Access Compliance Report

Public Rights-of-Way

(Curb Ramps)

Intersection ID: 24197	Main Street: CHINA GROVE CHURCH RD	Cross Street: ERVIN LN	Location: NE
ADA ID: A637441E106F	Ramp Type: ParaDiag	Initial Pass/Fail: Fail	Overall Compliance: No
Severity Score: 12.5			
Codes/Mitigation Info/Possible Solution		Field Measurements/Component Compliance

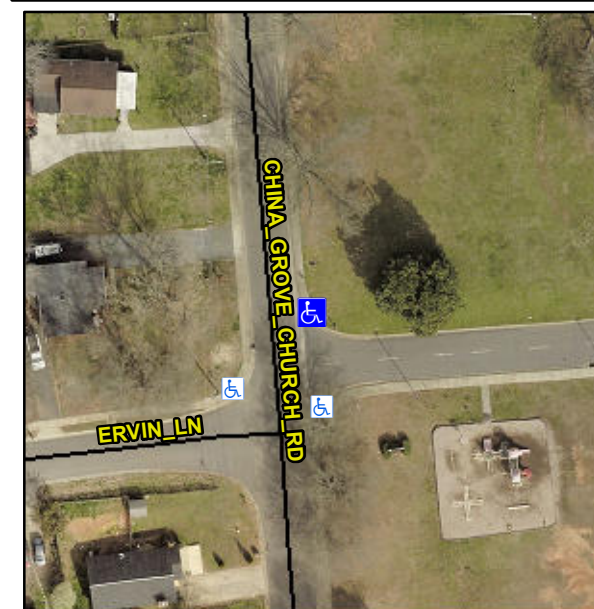
RT RP < 5%

PROW/ADA:

R304.3.2

Remove & Replace Curb Ramp With Two New Directional Ramps or Equivalent.
